In the matter of applications by Oceana Gold (New Zealand) Limited for  
resource consents for the Deepdell North Stage III Project

**Statement of evidence of Eric Torvelainen for Oceana Gold (New Zealand)  
Limited**

**Deepdell North Stage III  
Horse Flat Road Embankment and Culverts  
Resource Consent – Effects Related to Technical Review Comments**

Project: Deepdell Stage 3  
Basin ID: Horse Flat Road - 1050mm ID Culvert

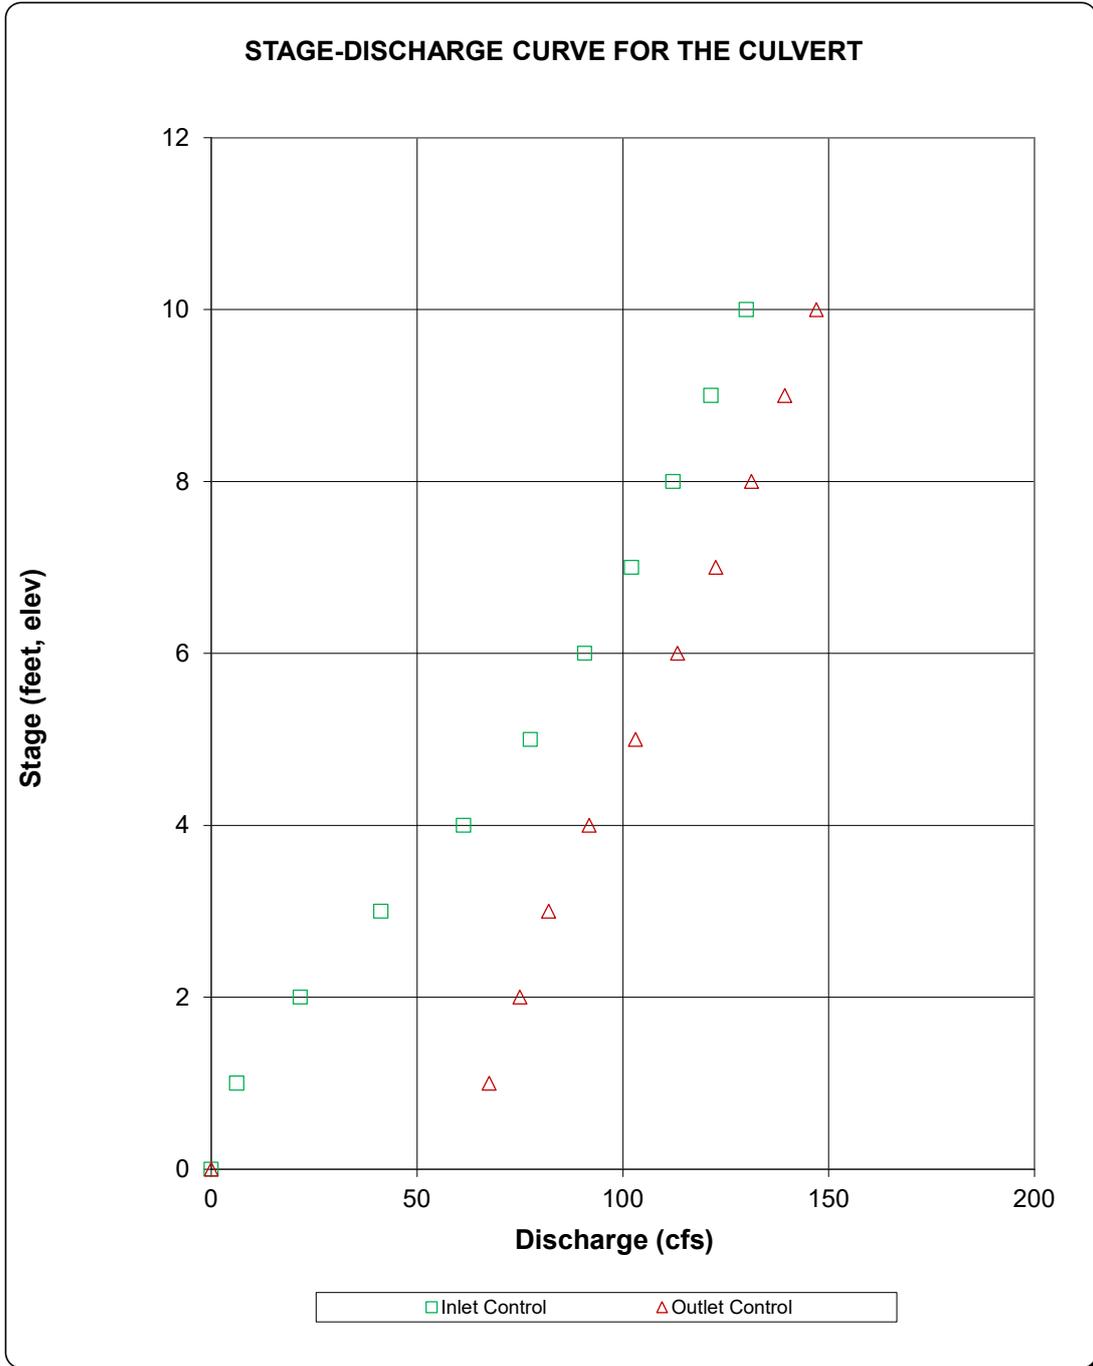
Tonkin & Taylor raised that permanent works be sized using the climate RCP6.0 scenario for the years 2081 to 2100. We had used historic rainfall estimates from the high intensity rainfall database version 4 (HIRDS V4). Rainfall intensity at the site for the 100 year ARI (average recurrence interval) event based on historical data is 81.9mm/hour for a 10 minute duration. The RCP6.0 scenario increases the intensity to 100mm/hr for a 10min duration.

The culvert through the road embankment at the eastern end of the realignment was previously sized to be 900mm internal diameter. Making the same assumptions and only increasing the rainfall intensity, the culvert pipe would need to be increased to 1050mm internal diameter to accommodate the climate RCP6.0 scenario. Updated calculations are attached. Alternatively, a double pipe culvert could be installed.

Use 1.7m3/s as design inflow

Project: Deepdell North Stage 3  
Basin ID: Horse Flat Road - 760mm ID Culvert

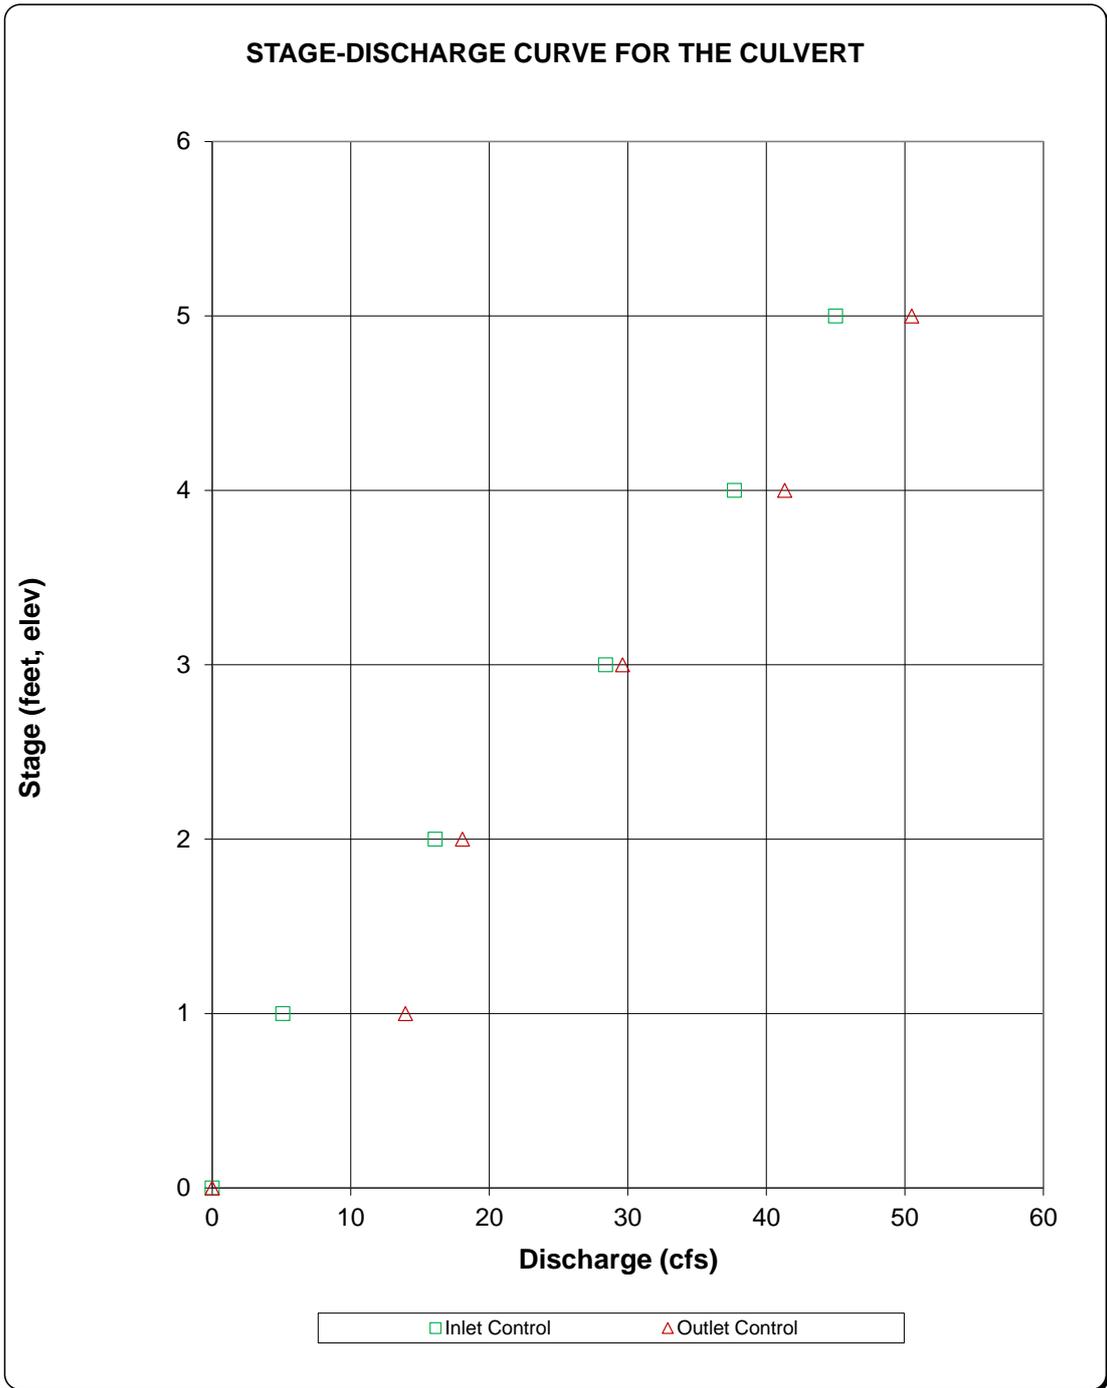
The culvert beneath the road at the western end of the realignment was previously sized to be 685mm internal diameter. Making the same assumptions and only increasing the rainfall intensity, the culvert pipe would need to be increased to 760mm internal diameter to accommodate RCP6.0 scenario. Updated calculations are attached. Alternatively, a double pipe culvert could be installed.

Use 0.86m<sup>3</sup>/s as design inflow
